**ACCESSIBILITY RECOMMENDATIONS – HEALTH CENTRE****QSTAPA CAMP - ERBIL – DECEMBER 2014****TO PROMOTE INCLUSION OF PERSONS WITH DISABILITIES, INJURIES AND OTHER VULNERABILITIES**

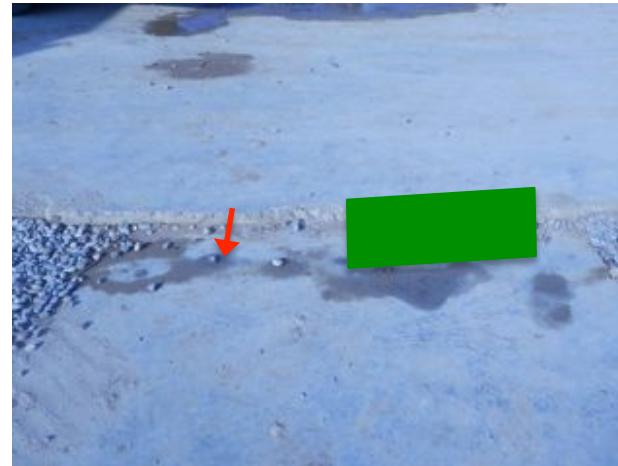
BARRIER AND DIFFICULTIES	PICTURE	Potential Solution
Entrance of IMC health centre has a concrete ramp, but it is a bit too steep for PWD to self-propel, it is 280 cm long for 40cm of height (1:7 ratio)		<p>Ensure ramp entrance of IMC is extended to respect 1:12 ratio of ramps (for every increase of HEIGHT by 1 cm, need 12 cm of LENGTH of ramp, or minimum 10cm length). See example of ramp later in report, can angle ramp as needed (but need platform for any angling).</p> <p>Also need to install a grab rail (see picture below) between day (large gate) and night entrance (small door) of PHC.</p>

Night entrance of IMC PHC is a good width, but at times has barrier blocking the way, also ramps is too steep and rocky.

Must ensure night entrance is kept barrier free and that metal door does not block it. Ramp to entrance to be fixed for entire area (night and day entrance) to be 1:12 in ratio.

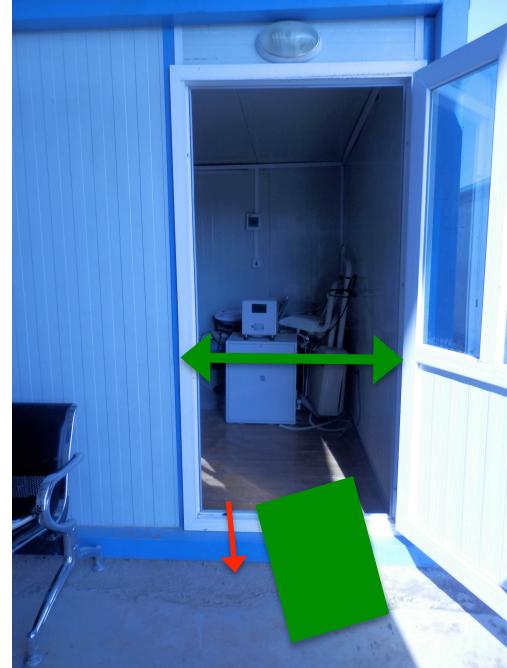
Some paths of PHC have a small step that can cause falls in elderly or persons with visual impairments

Try to smooth over these steps, with small ramp.
